## TECO TECH

Electromechanical locking wheel balancers  
Update of clutch anchor fixing screw type

N. 02 28/07/2025

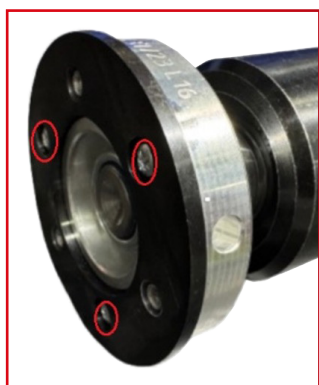
In the constant endeavour to improve our products, a modification has been made to the type of screw used to fix the clutch anchor to the aluminium shank, in wheel balancer models equipped with electromechanical locking.

▶ **As of July 2025**, M3x5 Allen screws (code 4-146283) were replaced with **M3x8 Phillips screws (code 2-02908)**, without washers.

**In rare cases**, on some machines produced between October 2024 and June 2025, **a possible loosening of the original screws was found**, which can generate interference with the clutch and affect the repeatability of the measurement.

Check the tightness of the three M3x5 screws (code 4-146283), arranged at 120° on the clutch anchor.

- ▶ **Replace them with M3x8 screws** (code 2-02908), without washers, applying Loctite 270 threadlocker or equivalent.
- ▶ **Check that the anchor** is not stuck to the shank. If this is the case, proceed carefully to detach it and complete the operation using a flat screwdriver (see example opposite).
- ▶ **Alternatively**, if the original screws are undamaged, they can be reused, ensuring they are tightened correctly using threadlockers.
